SERVICE INFORMATION BULLETIN

APPLICABILITY: 2020-21MY Outback **NUMBER:** 12-320-21

SUBJECT: Front Outer Door Garnish -Design Change

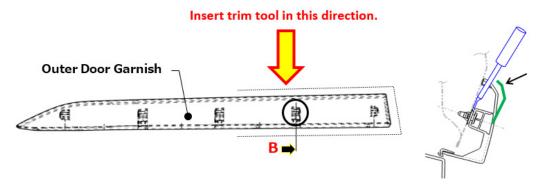
This Service Information Bulletin announces a design change made to the front door outer garnish trim. The change involves use of high strength clips added to improve retention of the garnishes and prevent any unintentional loosening / removal caused by the user's feet when entering and exiting the vehicle.

When removing the garnishes, **ALWAYS** use a suitable plastic trim removal tool. Do **NOT** reuse or reinstall the Front Outer Door Garnish because the retaining clips are only to be used once.

STEP 1) Start garnish removal by releasing **CLIP A** first.

STEP 2) Release CLIP B second.
